**Reference: Residential Development – 1040 Somerset Street West
Community Transportation Study (CTS)/Transportation Impact Study (TIS)
Addendum #1
Our File No. : 112191**

The purpose of this addendum is to outline changes to the proposed site plan, address transportation comments received from the City on August 2, 2013 and provide additional intersection analysis in support of revised recommendations. A comprehensive comment/response letter to all technical circulation comments is provided under separate cover.

FUNCTIONAL DESIGN OF
LEFT TURN LANE

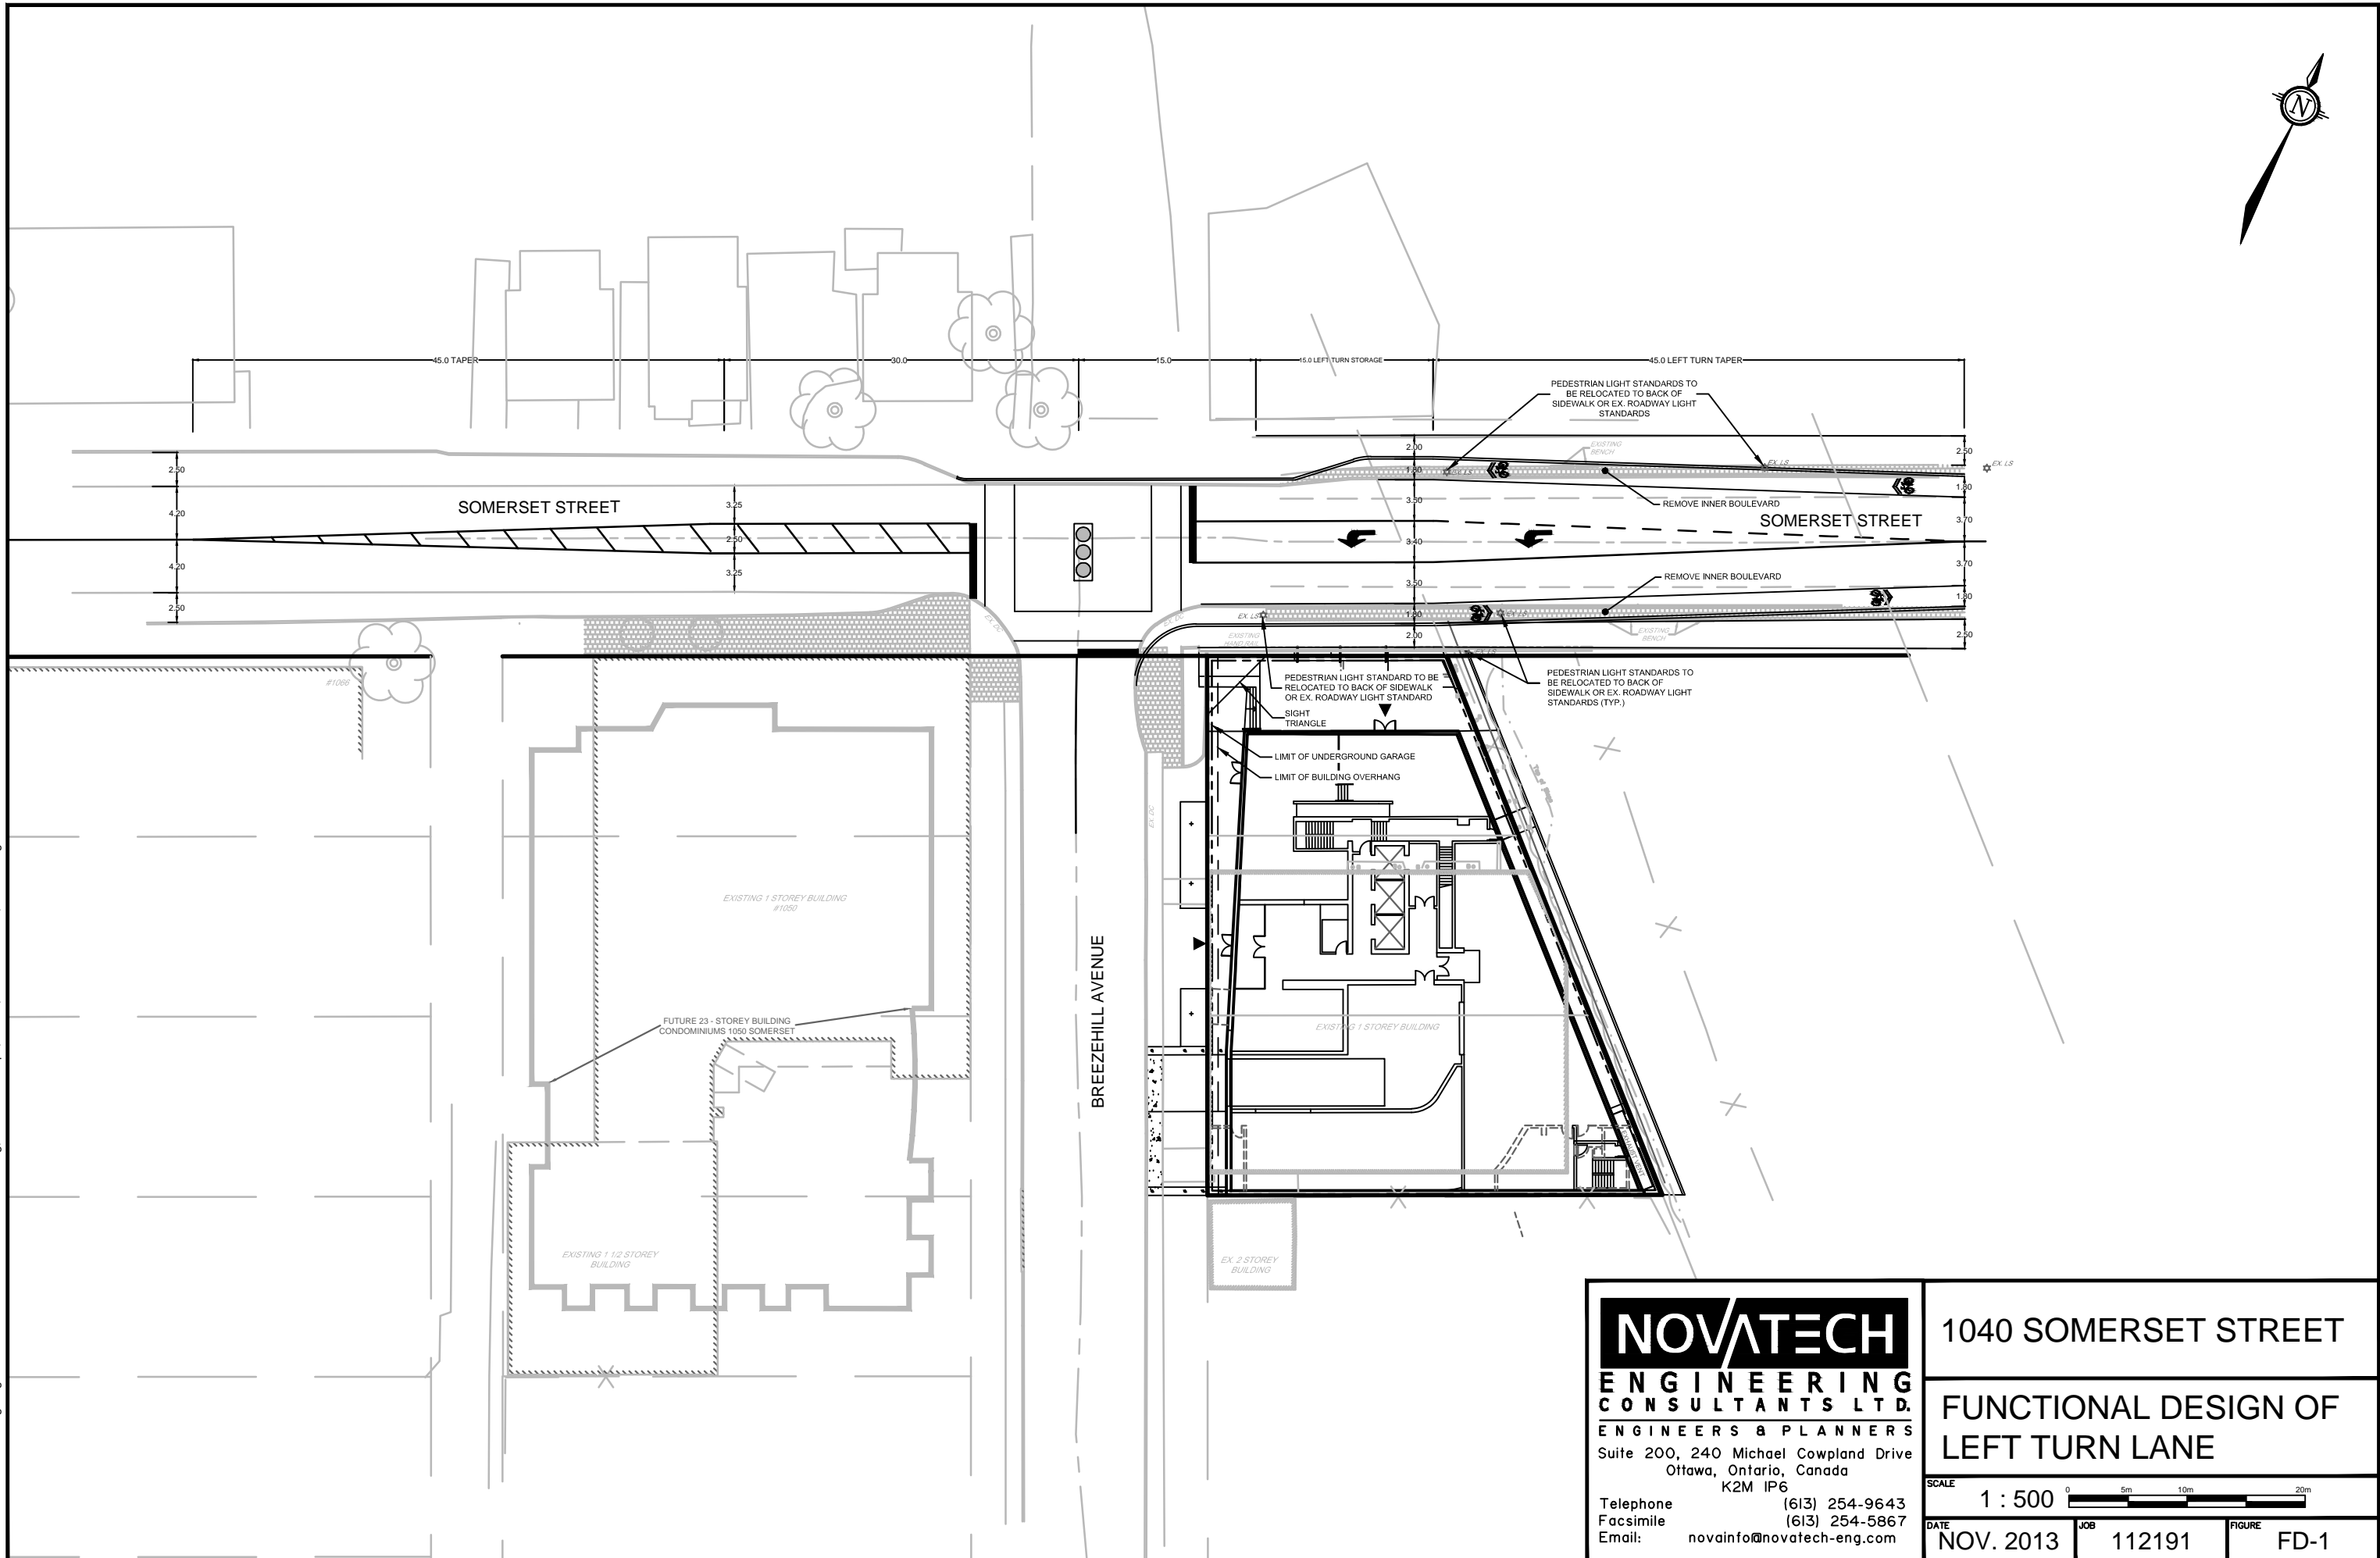
Option 5 has been considered in response to the City's request for more detailed information on lane widths, clearances and the potential for passing on the right. The westbound approach currently consists of 2.5m sidewalks, 1m inner boulevards, 1.8m bike lanes and two 3.7m general travel lanes. Pedestrian lighting is located in the inner boulevards on either side of the overpass. Further review of the existing geometry suggests that a 3.4m left turn lane could be accommodated through the elimination of the inner boulevards for a minimum distance of 60m across the bridge, relocation of the pedestrian lighting to the back of sidewalk or to the streetlight poles at the back of the guardrail, and a reduction of the sidewalk widths to 2m. The functional design of the proposed left turn lane is shown in **Figure 1**. If reduced sidewalk widths are not desired, an alternative cross section with 3.25m general travel lanes and a 3m left turn lane could be considered.

This option accommodates the left turn and through vehicular movements, avoids the need for turn restrictions at Breezehill and alleviates the concern of encroachment into the dedicated bike lane, however, it requires a modification of the recently reconstructed cross-section on Somerset Street.
